# Intel® Pentium® 4 Processor

## Specification Update

*September 2003*

Document Number: 249199-041

**Table System Bus AC Specifications (Reset Conditions)**

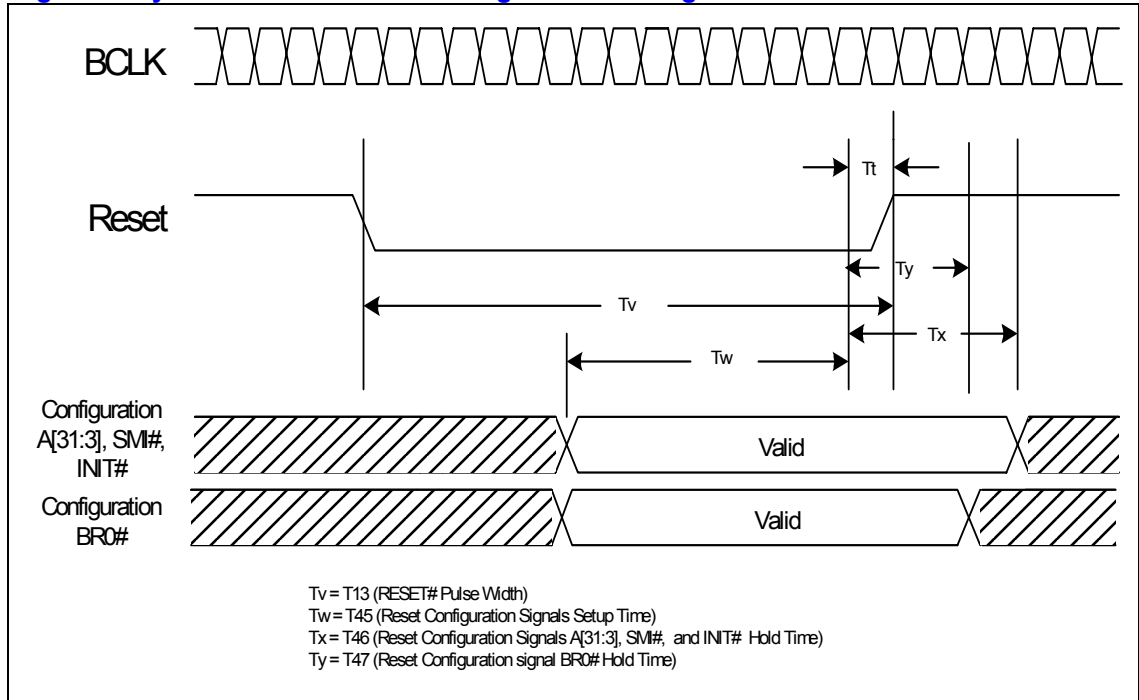
## N2. BR0# Maximum Hold Time Specification Change

The BR0# maximum hold time has changed to 2 BCLKs. This change will be shown in the “System Bus AC Specifications (Reset Conditions)” table and “System Bus Reset and Configuration Timings” figure of the Intel(R) Pentium(R) 4 Processor with 512KB L2 Cache on 0.13 Micron Process EMTS & Intel(R) Pentium(R) 4 Processor in the 478-pin Package Electrical, Mechanical, and Thermal Specifications (EMTS) & Intel(R) Pentium(R) 4 Processor in the 423-pin Package Electrical, Mechanical, and Thermal Specifications (EMTS). These changes will be incorporated in the next revision of the EMTS (Datasheet).

T# Parameter	Min	Max	Unit	Figure	Notes
T45: Reset Configuration Signals (A[31:3]#, BR0# INIT#, SMI#) Setup Time	4		BCLKs	12	1
T46: Reset Configuration Signals (A[31:3]#, INIT#, SMI#) Hold Time	2	20	BCLKs	12	2
T47: Reset Configuration Signal BR0# Hold Time	2	2	BCLKs	12	2
